Docket # 2023 NOV

RE: PacifiCorp's Response to Notice of Violation – NOV\_CAD\_PC\_YLO\_20240508\_1002

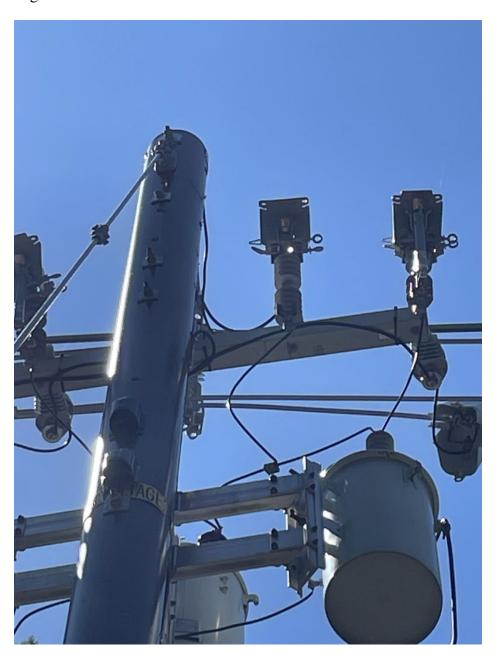
**Violation 2.** In response to the notice of violation, the company conducted a field inspection on June 26, 2024. Energy Safety observed that in implementing 2023 WMP initiative 8.1.2.12 - Expulsion Fuse Replacements, PacifiCorp failed to complete Expulsion Fuse Replacement on pole ID 06240004.220600 at coordinates 41.299622298582, -122.305498392864. Energy Safety considers this completeness violation to be in the Moderate risk category.

The fourth cutout was installed at the time of work and is connected to the system neutral. The cutout has the required guarding and covered jumper conductor. There is not a fuse currently installed in the cutout, and it therefore meets the requirements for exemption. PacifiCorp has no further plans for wildfire mitigation work at this location.
